HISTORIC AND DESIGN REVIEW COMMISSION

August 16, 2017

HDRC CASE NO: 2017-395
ADDRESS: 217 CEDAR ST
LEGAL DESCRIPTION: NCB 2963 BLK 11 LOT N 52.52 FT OF 1
ZONING: RM-4 , H
CITY COUNCIL DIST.: 1
DISTRICT: King William Historic District
APPLICANT: Jim Poteet/Poteet Architects
OWNER: Jim and Mary Poteet
TYPE OF WORK: Construction of a rear addition, porch column replacement, exterior modifications
REQUEST:

FLOOR PLAN: PROPOSED

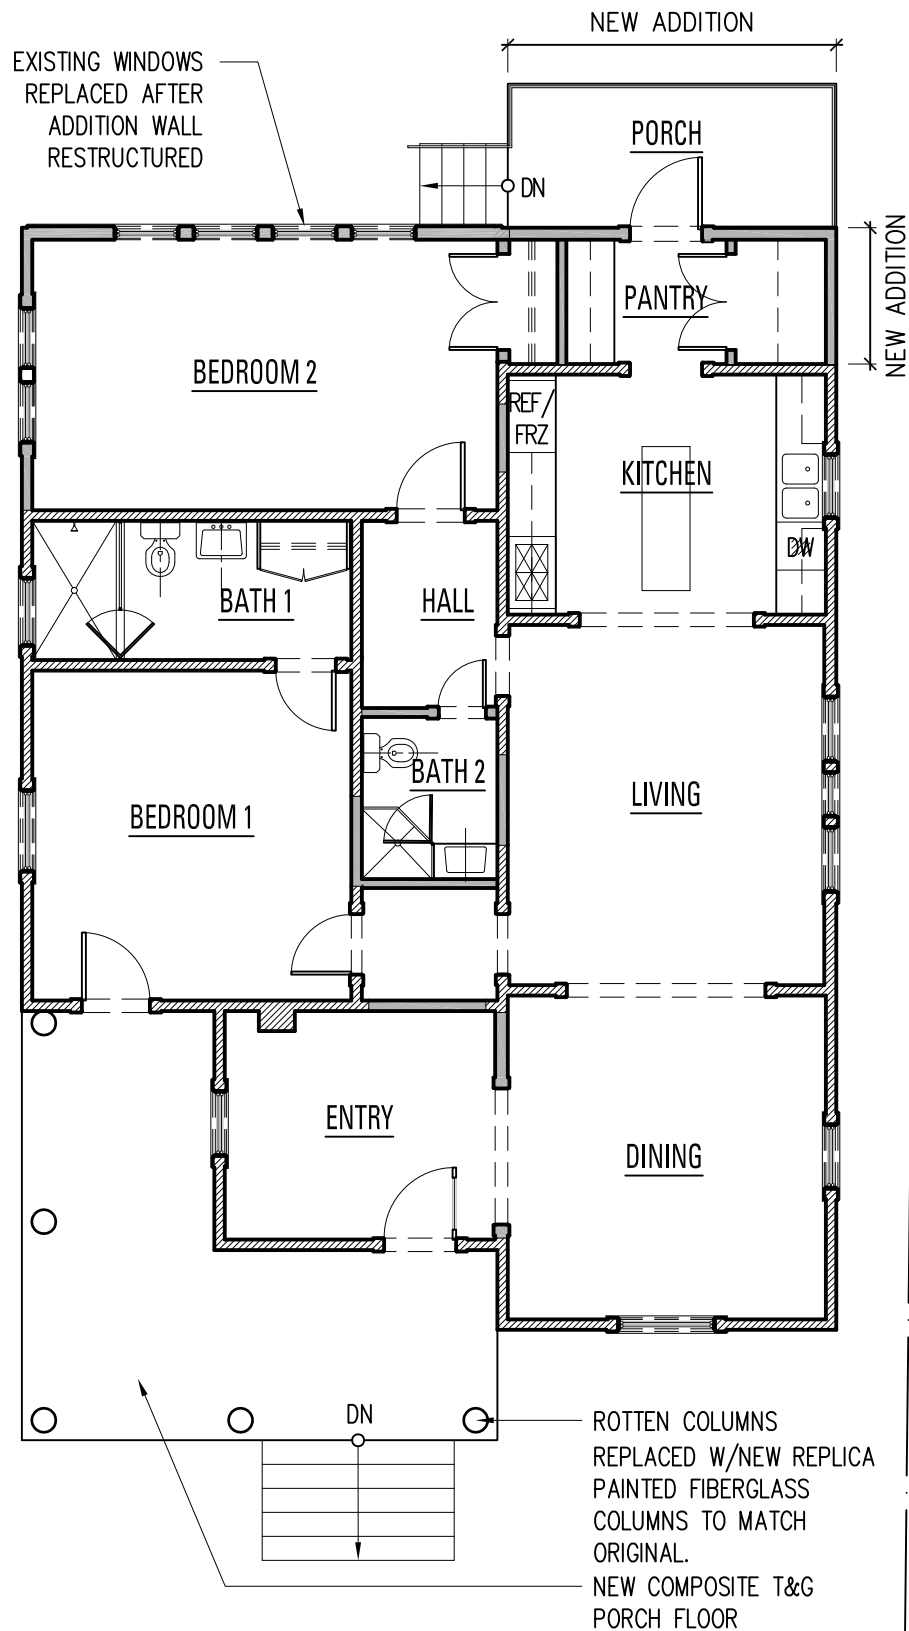
- e. **REAR PORCH ADDITION** – The rear of the historic structure currently features an enclosed porch that has significant structural damage. The applicant has proposed to reframe and reconstruct this enclosed porch with six of the original ten wood windows and board and siding. The removal of the corner windows will allow for proper framing. Per the Guidelines for Exterior Maintenance and Alterations 7.B.ii., original architectural details should not be obscured by any screening or enclosure materials. Alterations to side and rear porches should result in a space that functions, and is visually interpreted as, a porch. Staff finds the proposed reframing and removal of four windows inappropriate as it would remove character defining features of the existing, enclosed porch.

Staff does not recommend approval of items #3, the reframing of a rear addition.

ELEVATION: WEST, ADDITION

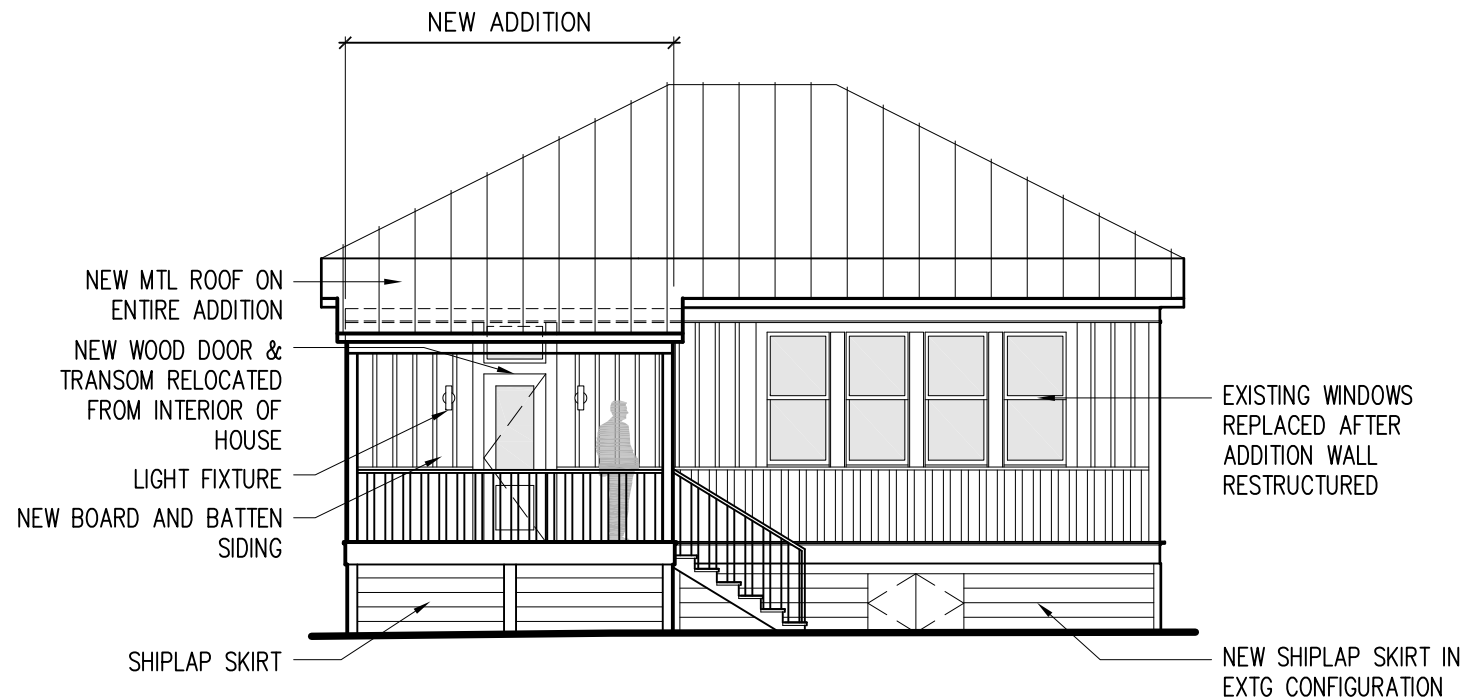
- f. **REAR ADDITION** – At the rear of the primary historic structure and to the right (west) of the existing porch, the applicant has proposed to construct a rear addition of approximately 84 square feet. The proposed addition will feature an attached porch, materials to include board and batten siding to distinguish it from the original structure. The applicant has noted the installation of a standing seam metal roof and shiplap skirting. The details of the standing seam metal roof should match those of the primary historic structure, including seams that are 18 to 21 inches in width, seams that are 1 to 2 inches in height, a crimped ridge seam and a color to match the original. The proposed skirting is to match the profile of that of the original skirting.

Staff recommends approval of item #4, the construction of a rear addition based on finding f with the following stipulations:

- i. That the standing seam metal roof match that of the primary historic structure, including seams that are 18 to 21 inches in width, seams that are 1 to 2 inches in height, a crimped ridge seam and a color to match the original. The applicant must contact staff 24 hours prior to installation in order to schedule an inspection to verify that metal roofing specifications are met.
- ii. That the foundation skirting match the profile of that of the original skirting.

Round Tapered Spun Cast

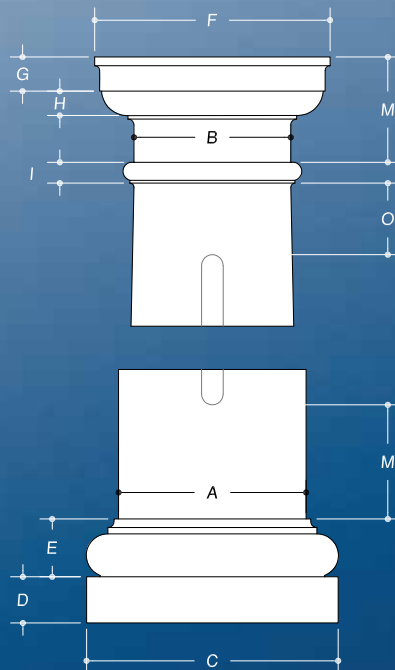
- c. PORCH COLUMNS – At this time, the applicant has proposed to install replicas of the tapered Tuscan columns that are made of fiberglass. While the proposed columns will feature fiberglass materials, the applicant has provided product specifications and examples of existing installations of the proposed fiberglass columns which notes appropriate scale, massing and details. Staff does not find the installation of fiberglass columns to be consistent with the Guidelines. Staff recommends the applicant first attempt to locate original columns to install. If this is not possible, staff finds that the proposed composite columns may be appropriate.

Staff does not recommend approval of item #1, the installation of fiberglass replacement columns. Staff recommends that the applicant first attempt to locate historic, replacement columns.
